Technical Service Bulletin: TSB260114	Released Date: 27-Jul-2026
MCI Motor Coach - Water Manifold Coolant Leak – Repair Procedure

- X12 CM2450 X137B

Figure 1, Coolant Leak Location Root Cause:

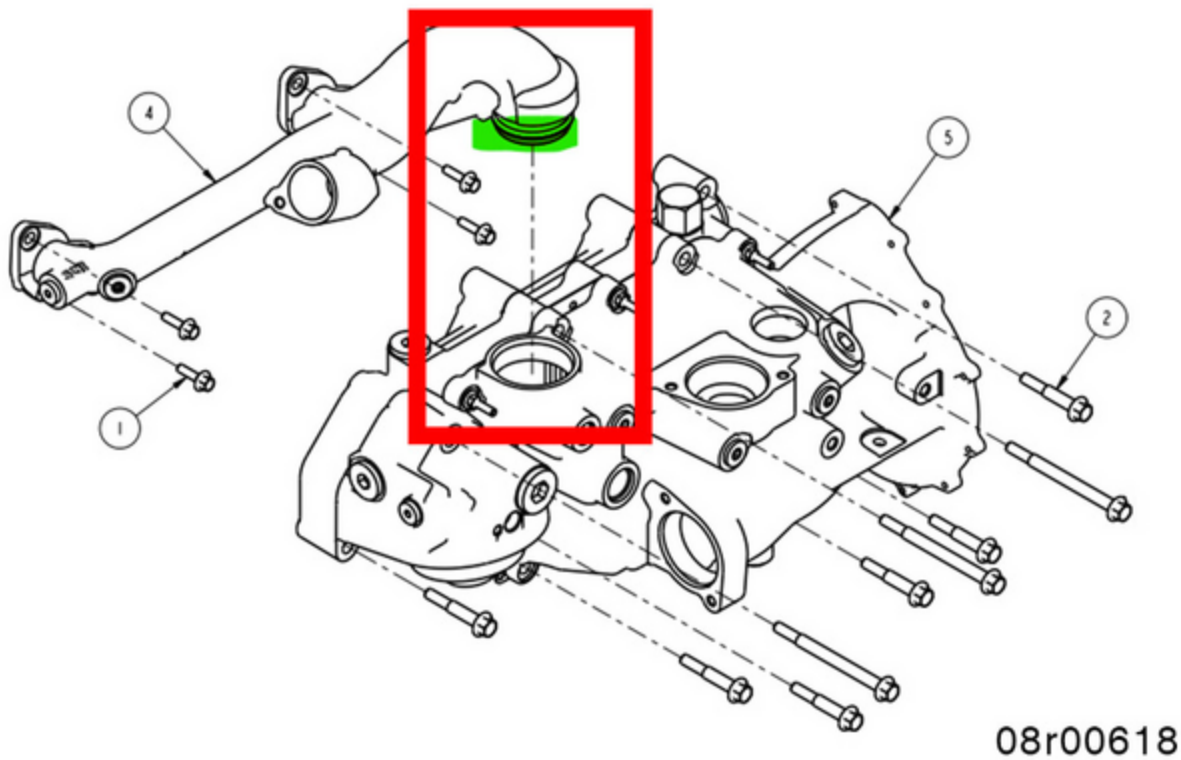
- Water manifold connection is **not** in specification. This issue affects engines in Motor Coach Industries® (MCI) Motor Coach **only**.

- If the connection shown in Figure 1 is leaking coolant and there is **not** a paint mark on the top of the water manifold, the manifold is **not** in specification.

- Replace water manifold, diamond ring seals, and o-ring. See Table 1.

- After the water manifold has been replaced; mark the top of the manifold with a paint pen to show the correct water manifold has been installed.
